MARK-UP OF SECTION 96 INCLUSIONS

16.07.2015 - 29.07.2016	A	DEVELOPMENT APPLICATION ISSUE SECTION 96 ISSUE	Morris Goding Elisa Moechar Phone: 9692 8000 Email: elisa@mgac.com.au	MDA Australia Damon Bissell Phone: 400 444 410 Email: damon@mda-aust.com.au	Chris Medland Phone: 9437 4611 Email: chris@medlandmetropolis.com.au	Brian Clarke Phone: 9437 4611 Email: brian@wilkinsonmurray.com.au	Tony Henslip Phone: 9211 7777 Email: tony@tmplg.com.au	Glenn Dixon Phone: 9332 3601 Email: glenn@360.net.au	WENONA SCHOOL 176 Walker Street, North Sydney NSW 2060 Phone: 9409 4406 Email: hmckenzie@wenona.nsw.edu.au	WENONA PROJECT ARCHEMEDES 255-265 Miller Street, North Sydney NSW 2060 PROJECT NO : 14010	Tonkin Zulaikha Greer Architects 117 Reservoir Street ABN: 4600272349 P: (02) 9215 4900 F: (02) 9215 4901 EMAIL: matilda@tztg.com.au WEB www.tztg.com.au	LEVEL 6 PLAN SCALES 1:100 @A1 PHASE SECTION 96 DRAWING NO A-1008 REVISION A	ABN, AVDB, JH, MW, SB, SD, CW CHECKED PT

16.07.2015 - 29.07.2016	A	DEVELOPMENT APPLICATION ISSUE SECTION 96 ISSUE	Do not scale off drawings. Use figured dimensions only. Report any discrepancies to the architect. These designs, plans, specifications and the copyright therein a

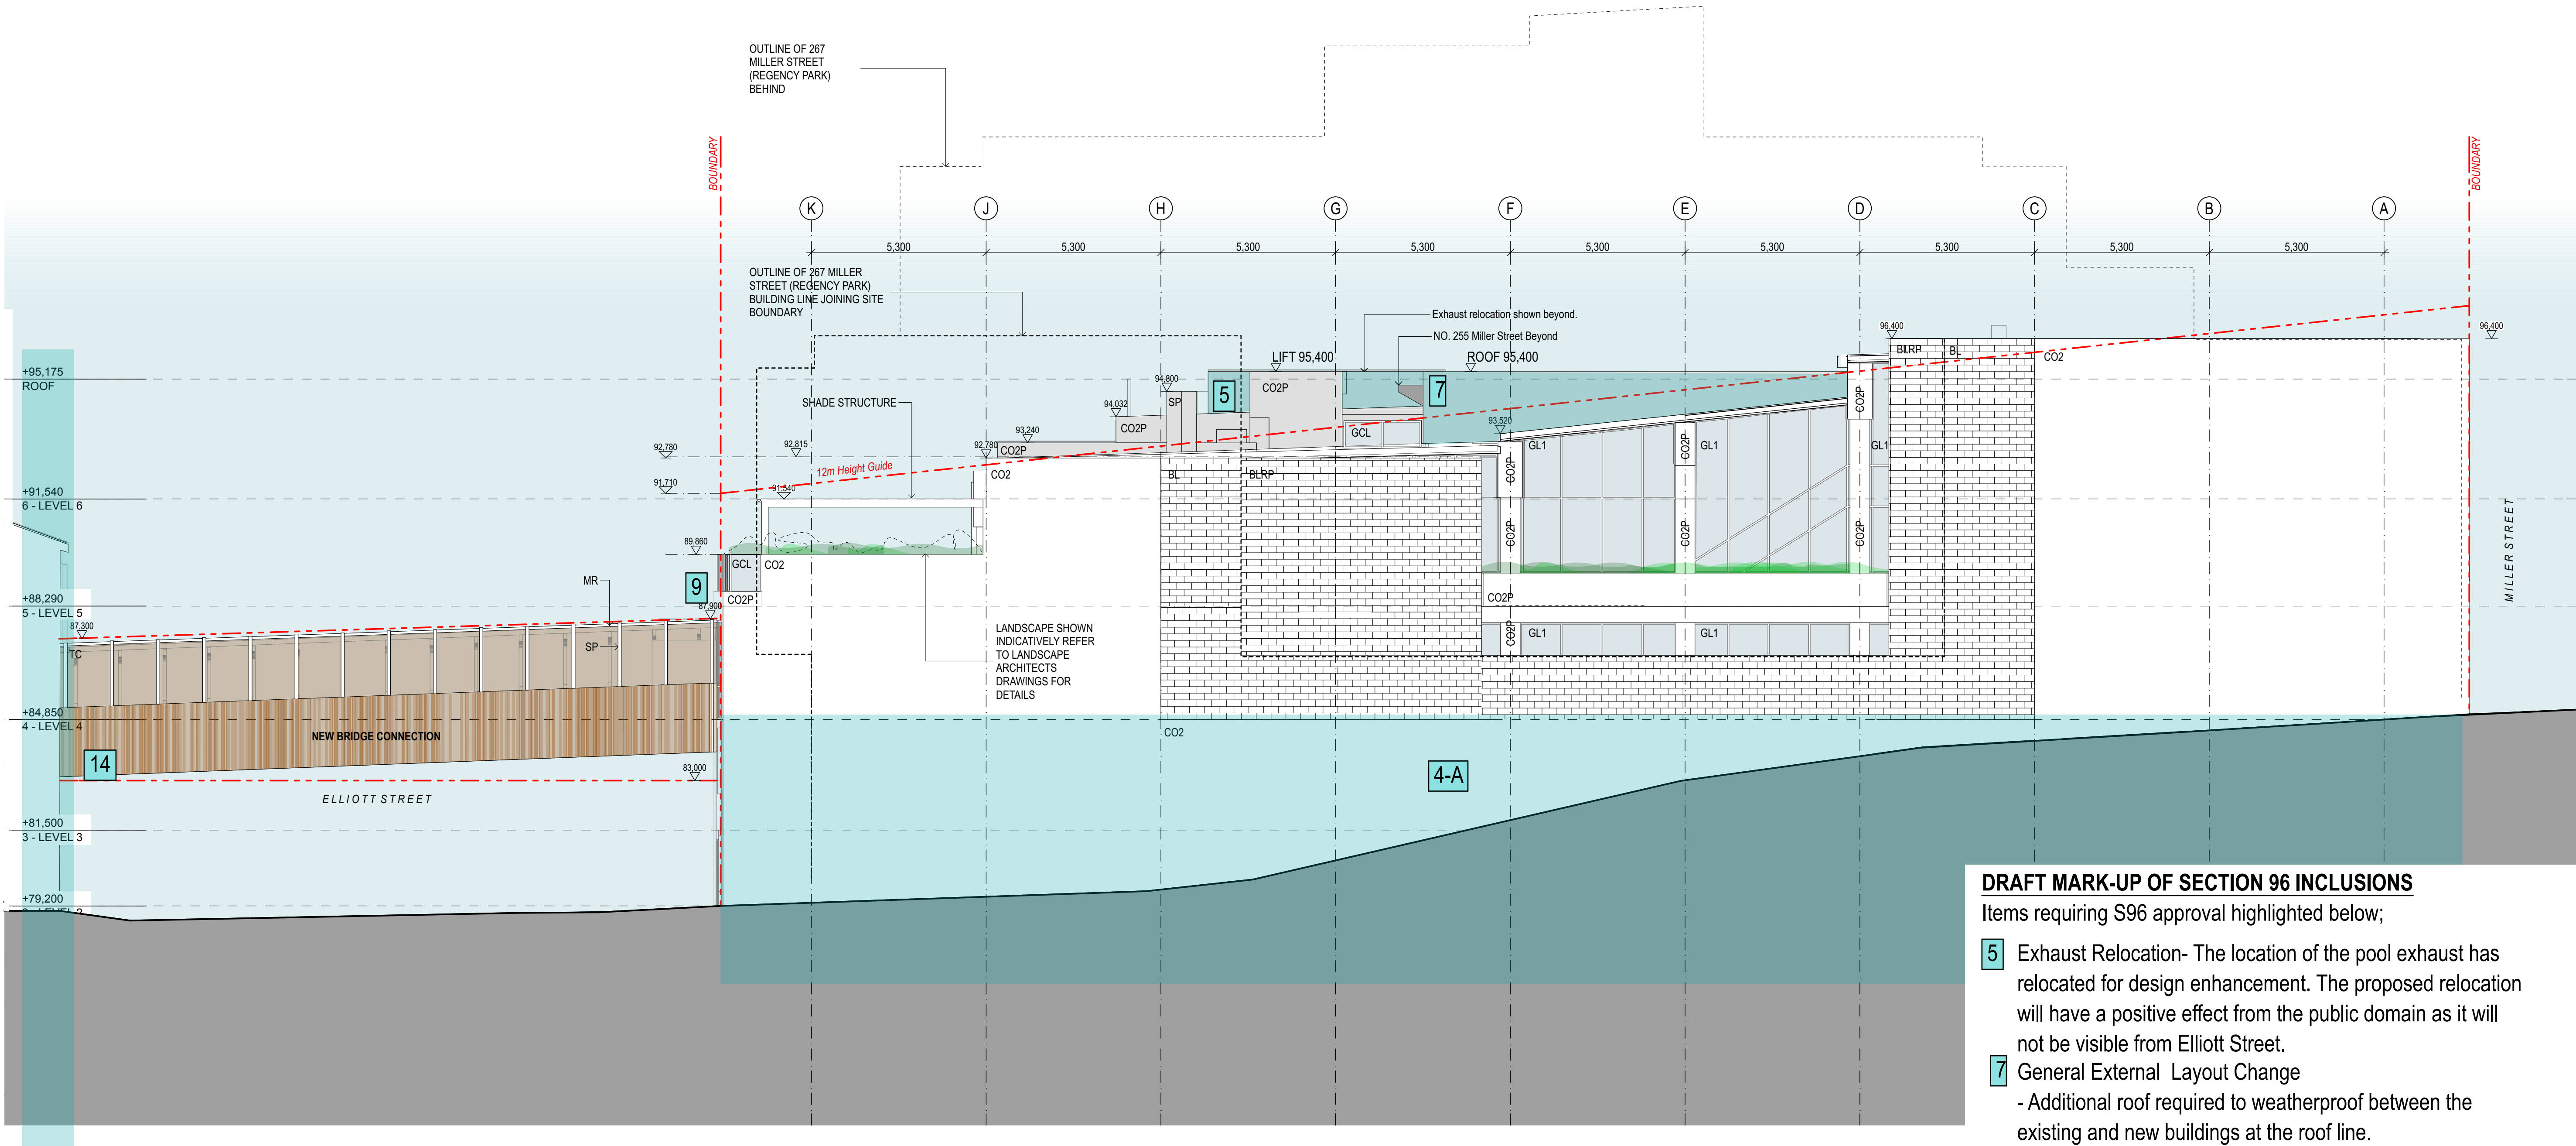
- 5** Exhaust Relocation- The location of the pool exhaust has relocated for design enhancement. The proposed relocation will have a positive effect from the public domain as it will not be visible from Elliott Street.
- 7** General External Layout Change
 - Additional roof required to weatherproof between the existing and new buildings at the roof line.
- 14** RL's for floor levels adjusted due to updated survey information on existing building floor levels
- 4-A** Shoring Design refer to STRUCTURAL + GEOTECHNICAL reports for details
- 9** Change to Balustrade
 - Change from 1100mm high concrete balustrade to 450mm high concrete planter wall with 1100mm height glass balustrade. Top of Wall height now 89.860

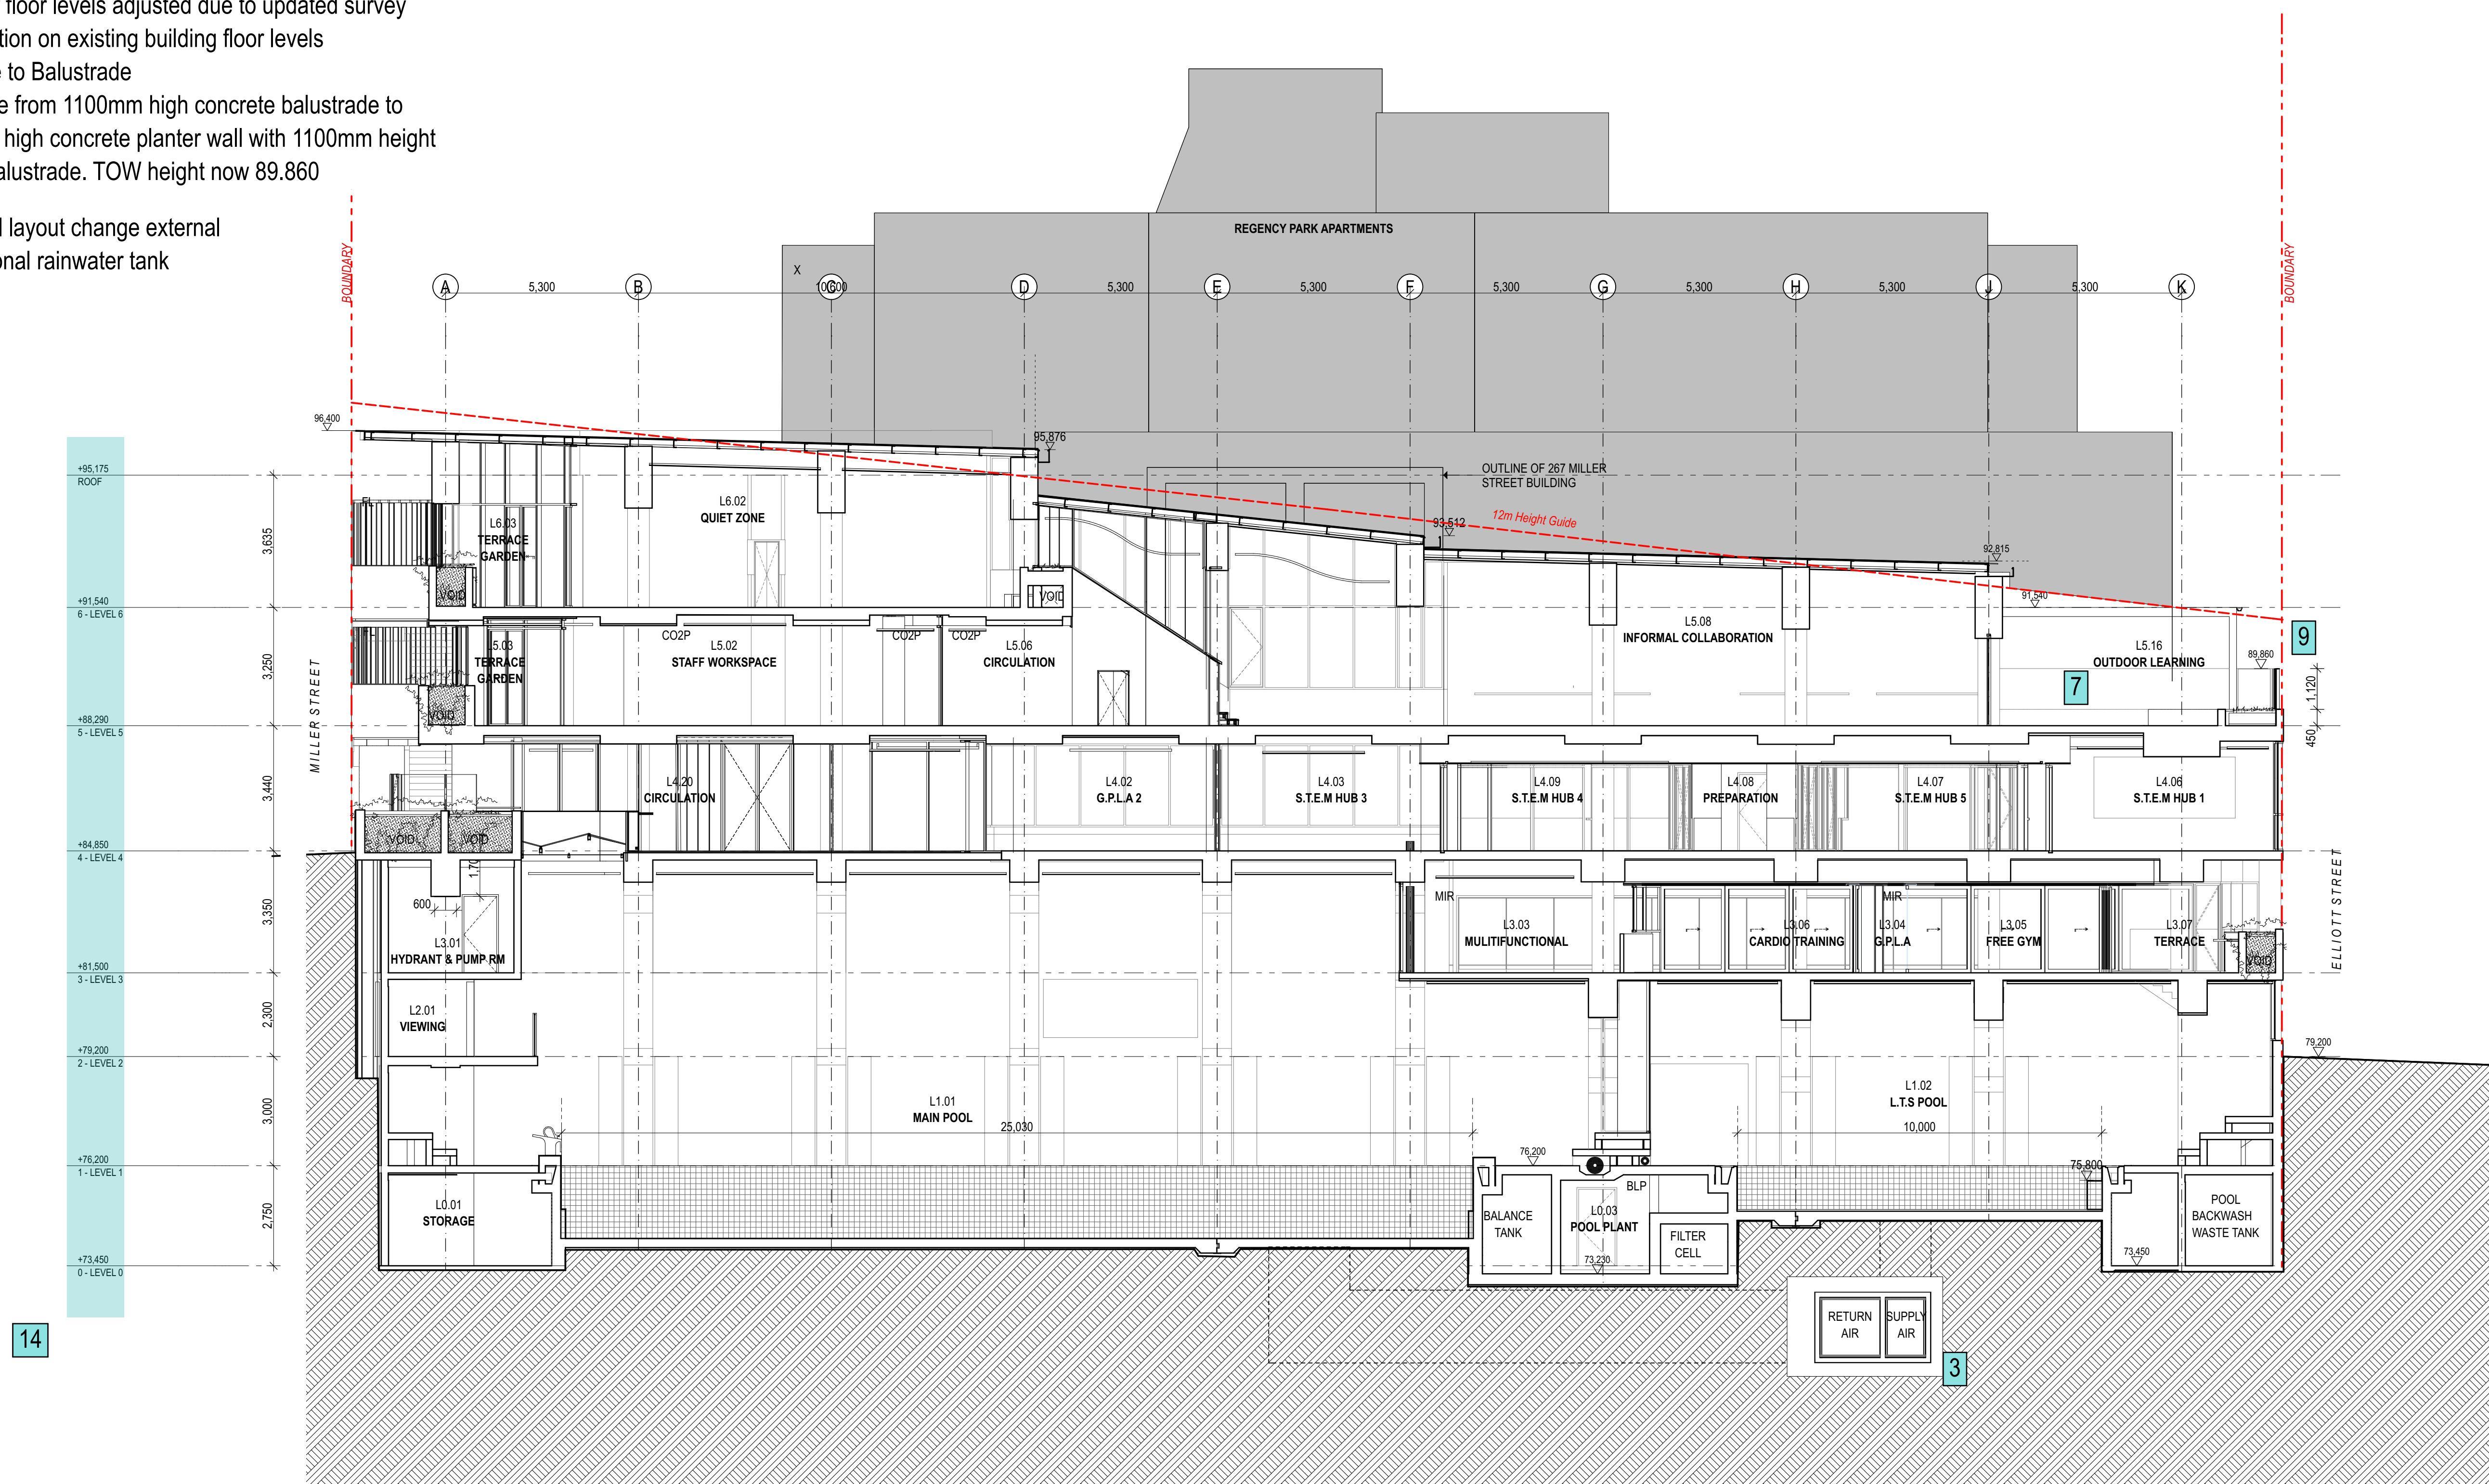
- 3 Further Development of Mechanical Trenching has occurred during documentation phase to serve the approved development.
- 14 RL's for floor levels adjusted due to updated survey information on existing building floor levels
- 9 Change to Balustrade
 - Change from 1100mm high concrete balustrade to 450mm high concrete planter wall with 1100mm height glass balustrade. TOW height now 89.860
- 7 General layout change external
 - additional rainwater tank

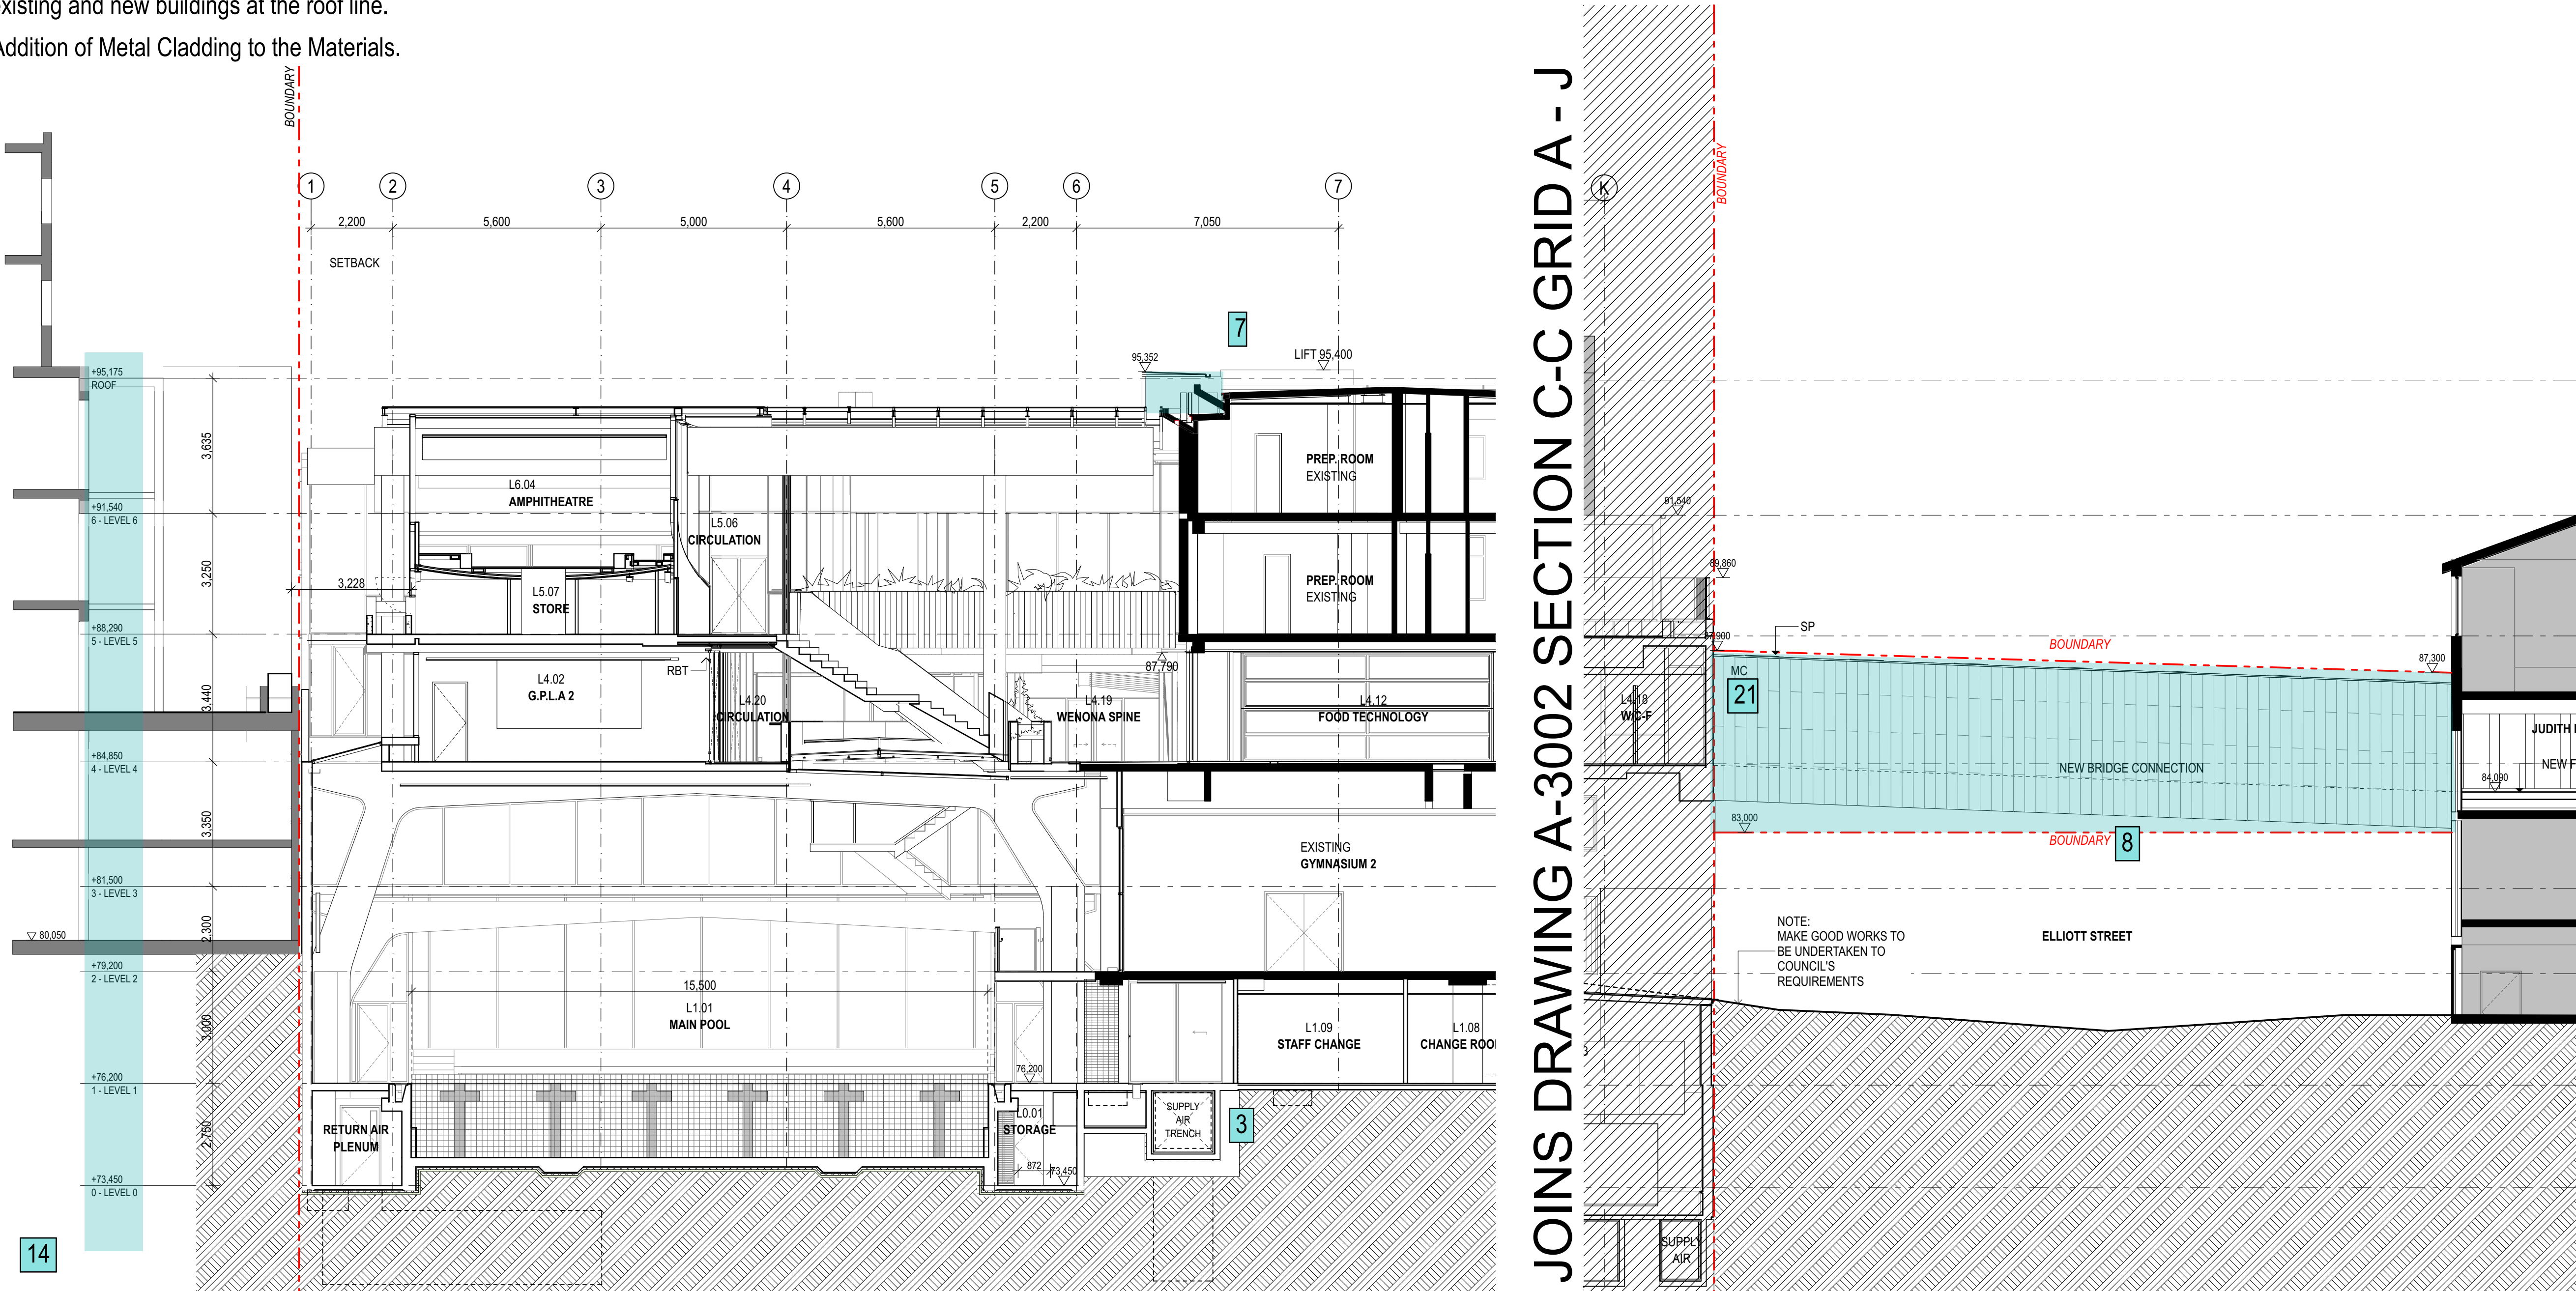
- 3
- Further Development of Mechanical Trenching has occurred during documentation phase to serve the approved development.
- 14
- RL's for floor levels adjusted due to updated survey information on existing building floor levels
- 8
- Boundary Adjustment to create revised allotment refer SURVEYORS documentation
- 7
- General External Layout Change
- Additional roof required to weatherproof between the existing and new buildings at the roof line.
- 21
- Addition of Metal Cladding to the Materials.
